**Knox County Procurement Division
Addendum I to Invitation for Bid 3361
Roof Replacement for Austin East Magnet High School**

ADDENDUM 01

PROJECT: A Roof Replacement for Austin-East Magnet High School | MHM 22049

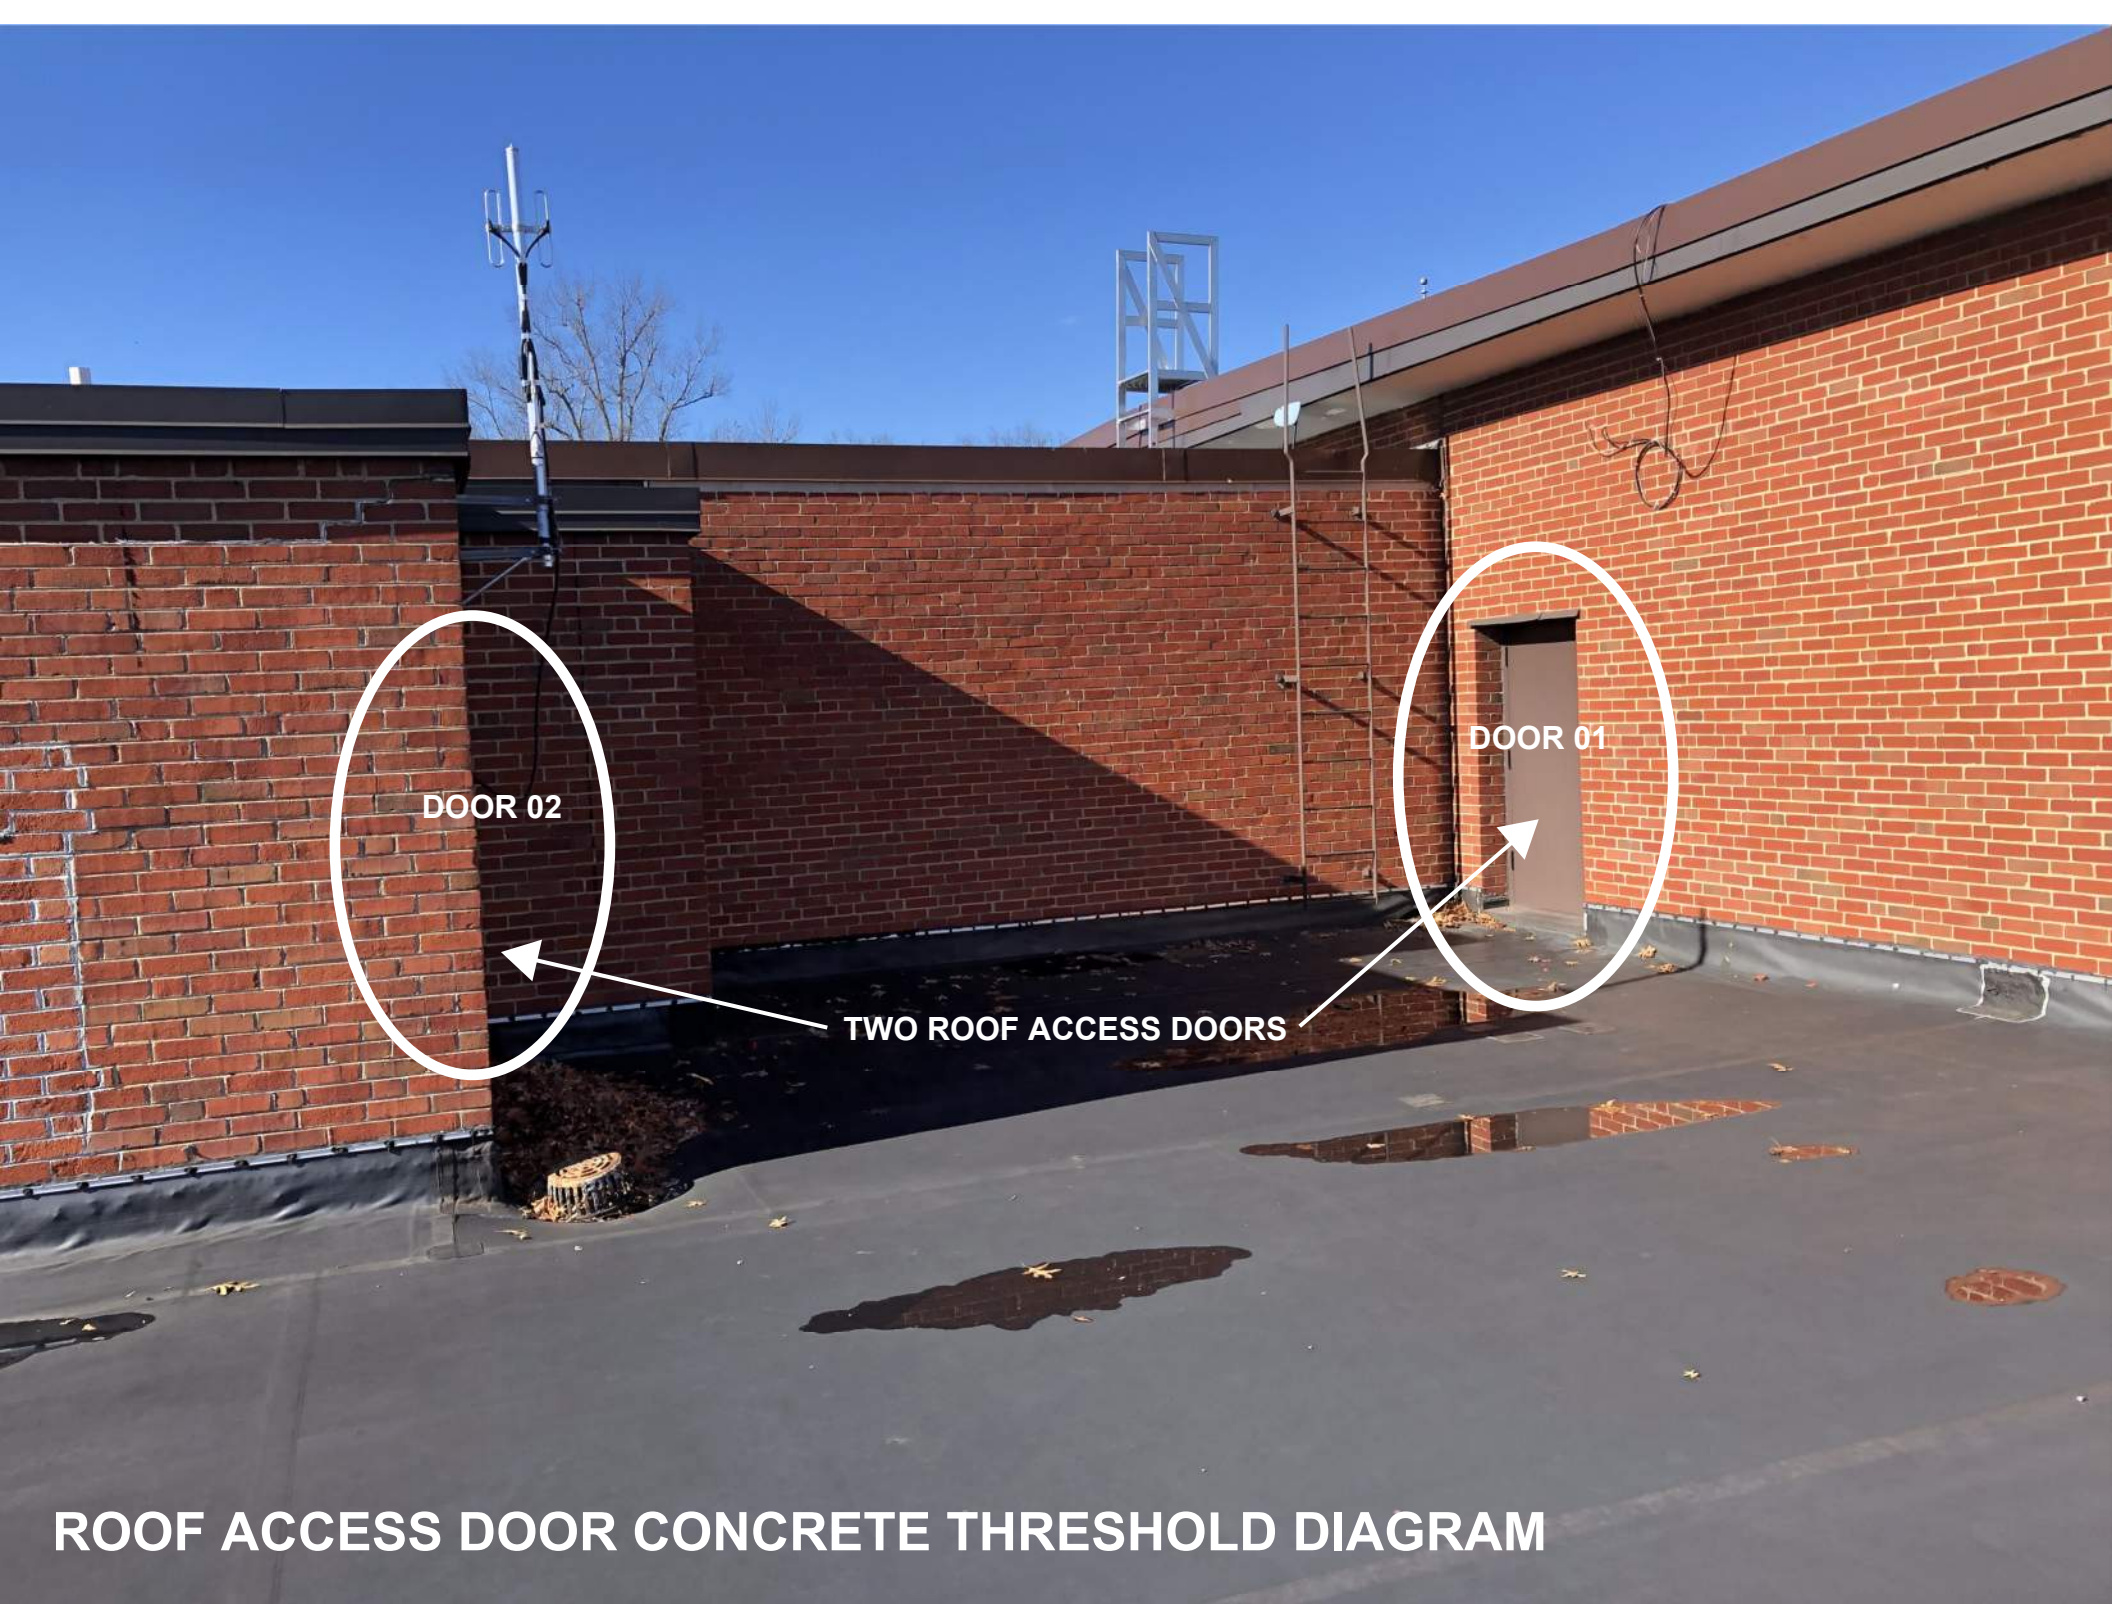
9. Sheet **G-001**: Updated Index of Drawings. Refer to bubbled changes on attached revised Sheet.
10. Sheet **A-115**: Roof Plan A10/A-115 – Modified roof slope and roof insulation thickness. Refer to bubbled changes on attached revised Sheet.

- a. RESPONSE: Contractor shall include in their Base Bid the scope of work currently included in the Construction Documents for this roof area.
13. Sheet **A-115**: QUESTION – Reference roof plan A10. It is noted to add 2 inches of ISO over the existing, this will cause the new roof system to be at or above the existing concrete window sill. Please clarify how you would like to handle this.

- a. RESPONSE: Contractor shall hold the current height of roof membrane at the high side of this roof area just below the window sill by reducing the added roof insulation thickness and sloping the roof downward at 1/8" per foot. As the roof slopes downward the roof insulation thickness shall continue to increase until it reaches the specified added thickness where the roof slope will transition to 1/4" per foot down to the bottom edge of roof.

- b. Refer to revised Sheet A-115.
14. QUESTION: There are numerous control joints throughout the building that have missing or very deteriorated caulking in them. These control joints will no doubt leak behind the new roof system. Please clarify how you would like to deal with this issue.

ROOF ACCESS DOOR CONCRETE THRESHOLD DIAGRAM

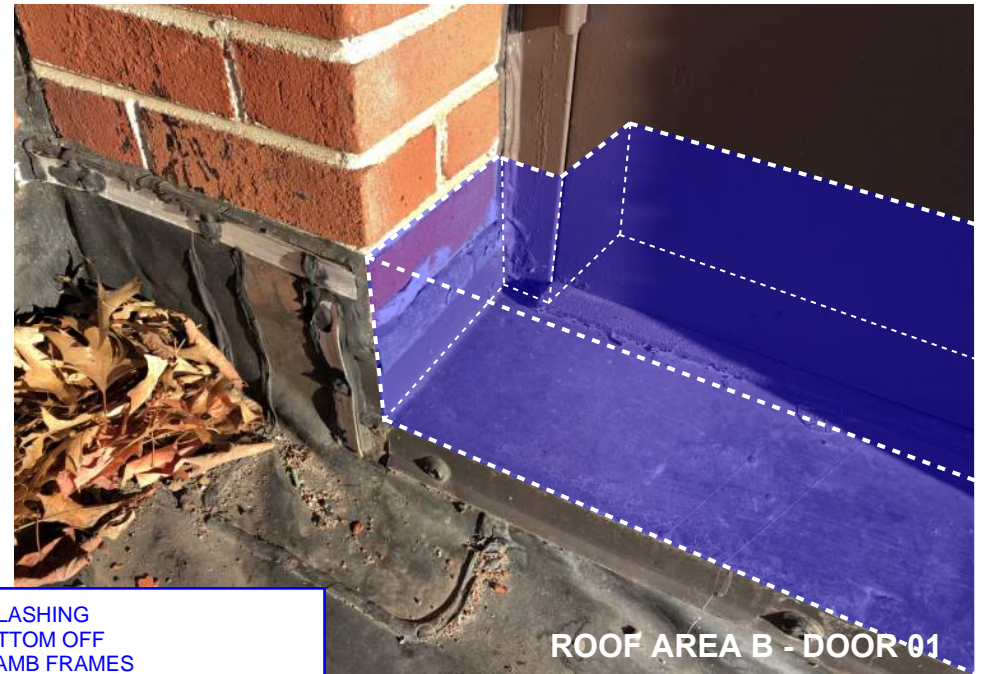
11. Sheet **A-112**: QUESTION – The roof area that the door comes out onto shows adding 3-3/4 inches of new ISO over top of the existing. The door thresholds are not high enough to allow that much insulation on this roof area. Please clarify how you would like to handle this.

- a. RESPONSE: Contractor shall include the following scope of work in their Base Bid for the two existing roof access doors at Roof Area B:
 - i. Remove the existing threshold and metal flashing, install two vertical #4 steel reinforcing dowels embedded and epoxied 6" into masonry wall below and 4" up into new concrete, and cast-in-place an 8" tall concrete (3,500 PSI) threshold within the existing opening the full width of the existing wall. Provide a positive downward slope of 1/4" per foot towards exterior on top side of concrete threshold.

- ii. Cut the bottom of the existing hollow metal door frame jambs off to provide a 1/4" space between the bottom of door frame jamb and the top of the new sloped concrete threshold.

- iii. Install new roof membrane up and over new concrete threshold and under door jambs and new aluminum threshold and seal at all edges. Include all necessary flashing and sealant to create a watertight condition.

- iv. Cut bottom of existing hollow metal door off 8" and install new metal plate stabilizer within bottom of existing hollow metal door. Existing door hardware shall remain with the addition of a new sweep on bottom of door and a new aluminum threshold installed and embedded into a bed of sealant.

- v. Prime and paint hollow metal frame and door.
 - vi. Refer to attached diagram sketch.
12. Sheet **A-112**: QUESTION – There is a small low roof area with a note that says add 4.5 inches of new insulation over top of the existing. This will cause the new roof system to be above the through wall counterflashing on that area. This is not a manufacturer accepted detail. All new terminations must be below any existing through wall counterflashing. Please clarify how you would like to handle this.

1. REMOVE THRESHOLD AND FLASHING
2. REMOVE DOOR AND CUT BOTTOM OFF
3. CUT OFF BOTTOM OF TWO JAMB FRAMES
4. DOWEL INTO WALL BELOW AND FORM / POUR CONCRETE
5. REINSTALL DOOR USING EXISTING HARDWARE
6. INSTALL ROOF MEMBRANE UP AND OVER CONCRETE
7. PRIME AND PAINT DOOR AND FRAME
8. INSTALL NEW THRESHOLD EMBEDDED IN SEALANT BED
